Building Permit Application

Permit No.: B16005164

MEMORANDUM

RE: Walnut Creek Lot #69
12162 Hayland Farm Way
Clarksville MD 21029
"Potential Basement Bedroom"

0 Bedrooms

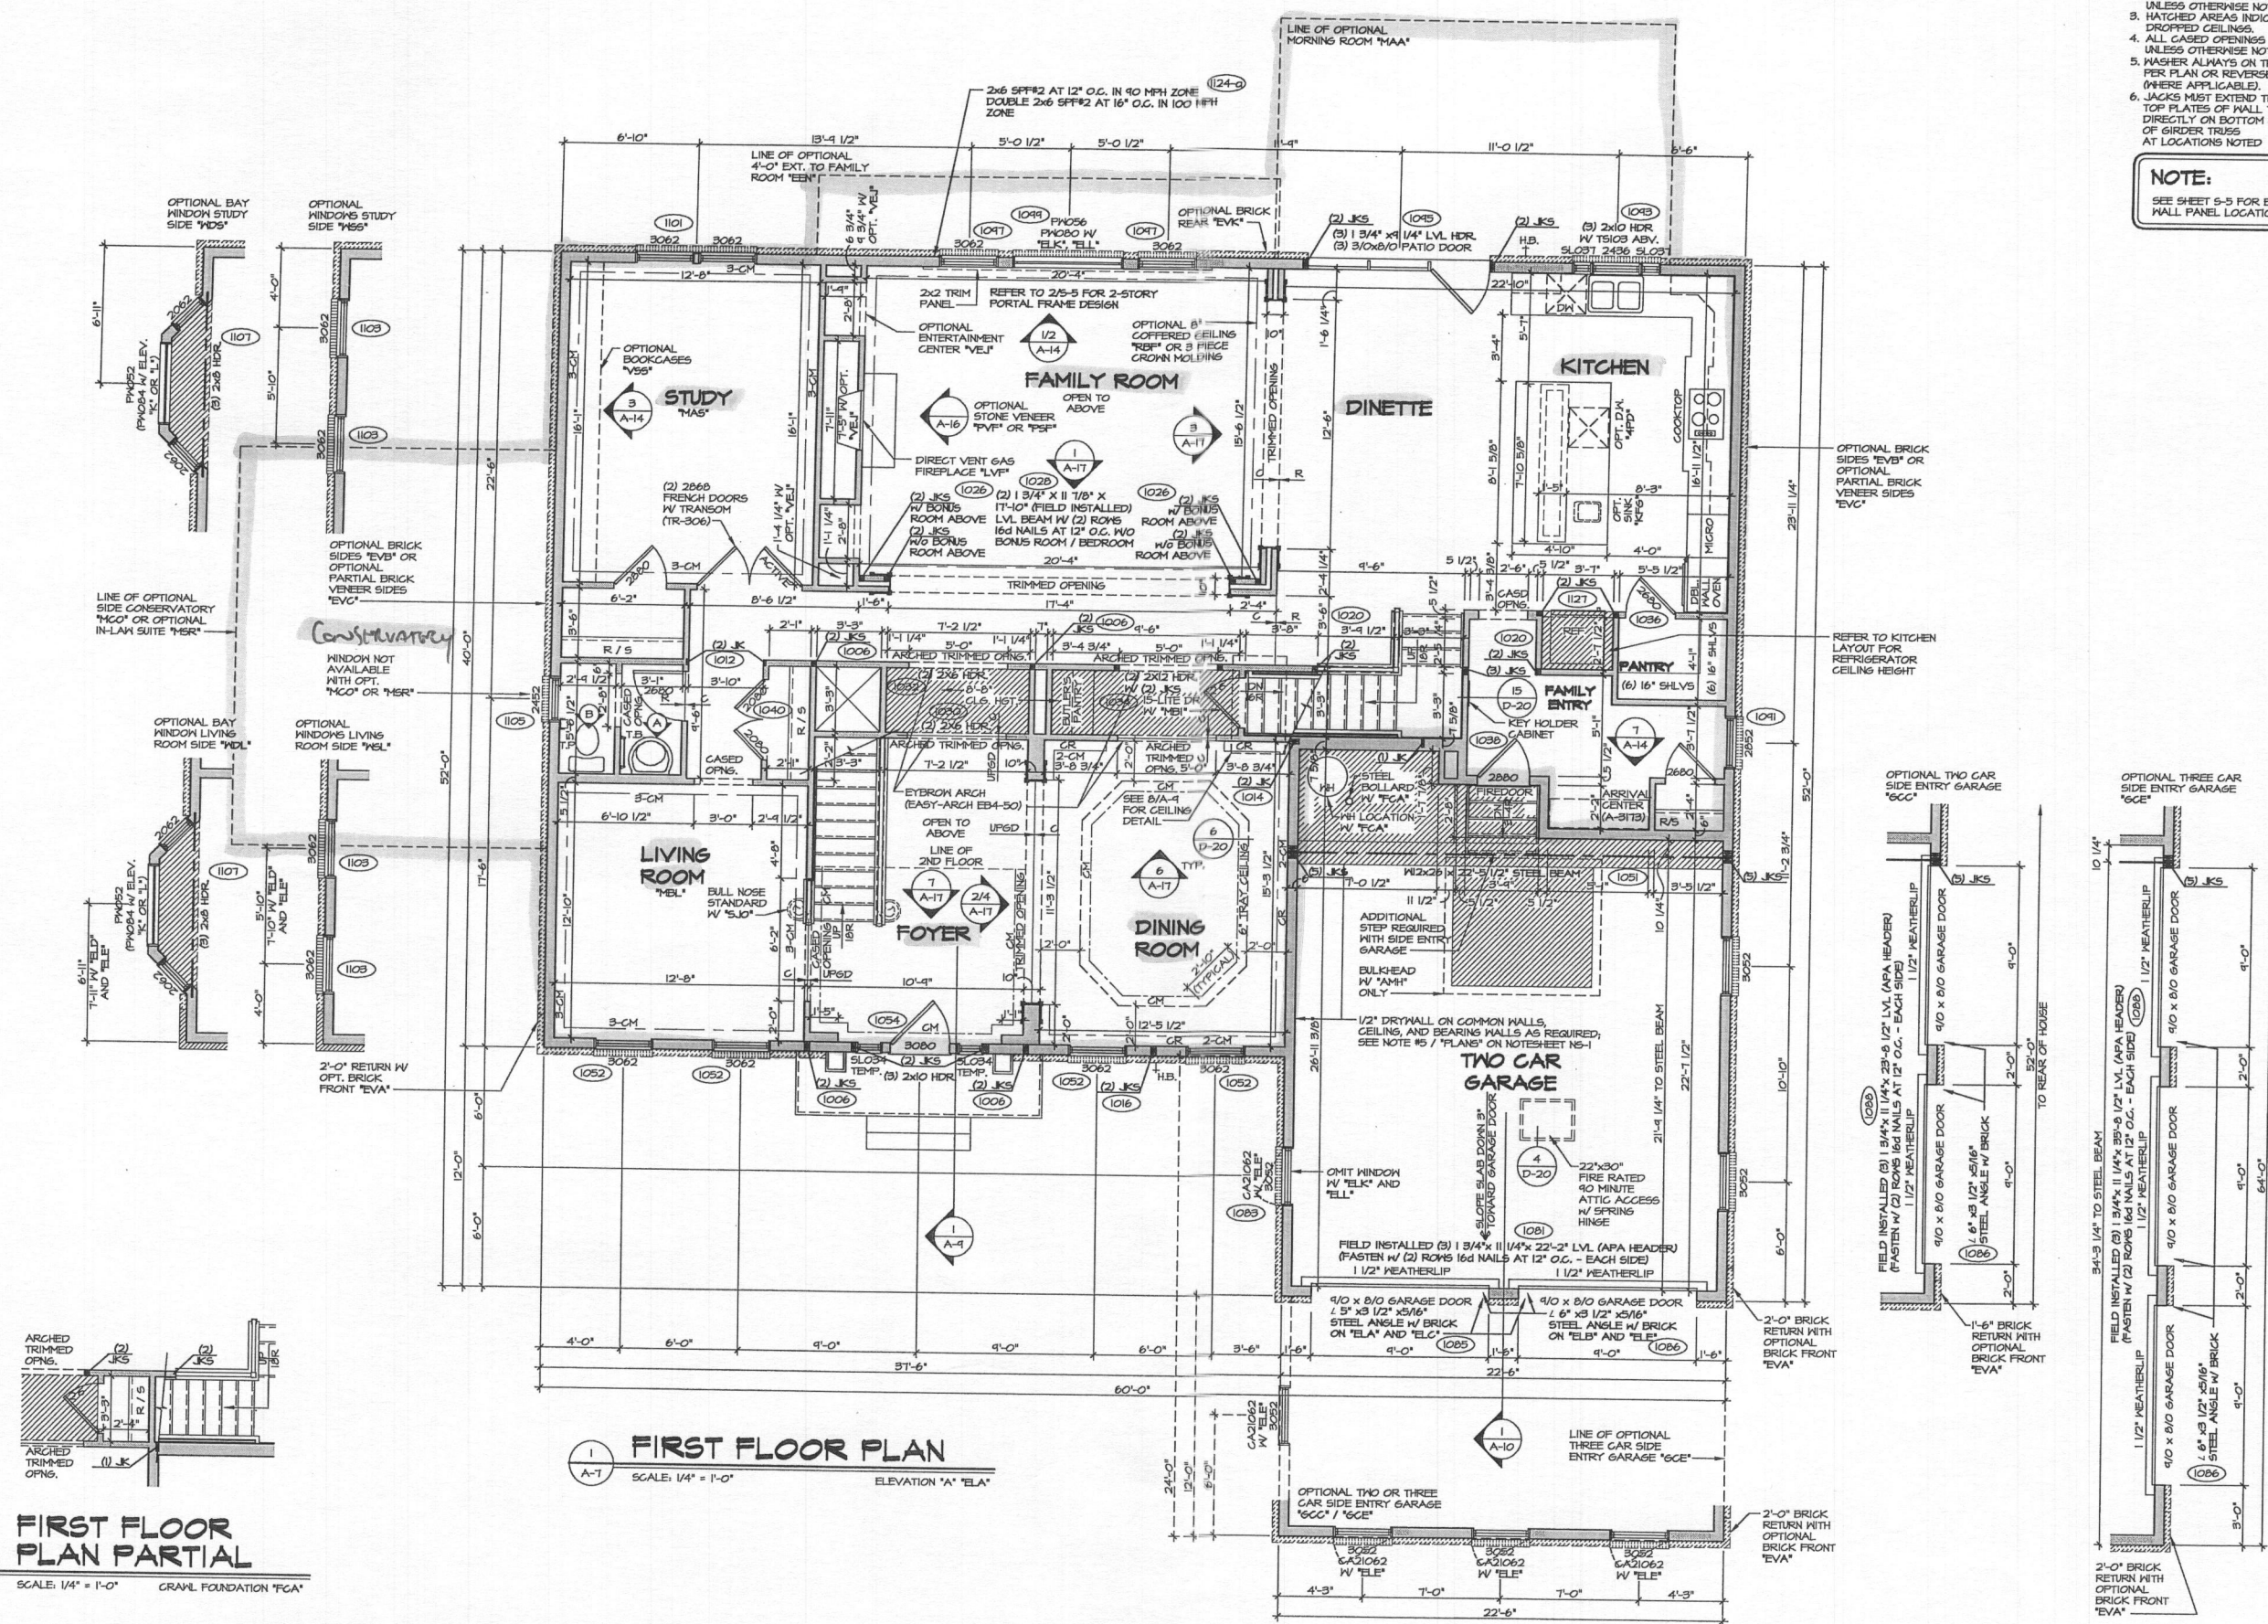
I have reviewed the floor plans in support of Building Permit **B16005164** for a new home at **12162 Hayland Farm Way** and noted the full bathroom in the unfinished basement. Please note that this makes it very likely for one or more rooms to be considered bedrooms upon conversion of the basement to finished living space. As this lot is connected to the shared sewage system with a **five** bedroom per lot limitation, any future building permit for converting all or a portion of the basement into finished living space may be denied by the Health Department if the total number of proposed bedrooms in the dwelling is above five.

If that is the case then I need someone to fill out a Revision Form at the Dept. of Inspections, Licenses and Permits (DILP) for the building permit (B16005164). The building permit itself does not need to be redone rather just made clear with what is actually being proposed. On the building permit itself it has finished basement written in and unfinished basement checked off. I will also need new floor plans sent to DILP with a copy for the Health Dept. As it stands now with the current floor plans along with what you have told me there is a comment I would like to make. The floor plans show a total of 5 finished bedrooms (1-BR 1st Floor, 4-BR 2nd Floor). Having the full bath or rough in for a full bath in an unfinished basement makes it possible to consider one or more rooms as bedrooms upon finishing the basement. The Opt. Home Office could be considered a bedroom upon finishing the basement with a full bath. There is a limit of 5 bedrooms per lot with in the Walnut Creek Shared Septic System. I have attached a memo with the Howard County

I have looked at the floor plans and noticed the OPT. BSMT BATH crossed out in the unfinished basement. Can you confirm whether or not this full bath is being roughed in?

Sorry Robert, I'm not sure why the basement bath was crossed out. The customer is getting the finished Rec Room and basement bath in this home

I am requesting to amend Permit # B16005164 at
12162 Hayland Farm way clarksville MD to
remove 1st Floor Bedroom option and to
add 5th Bedroom over the conservatory and to
confirm that the Basement is finished
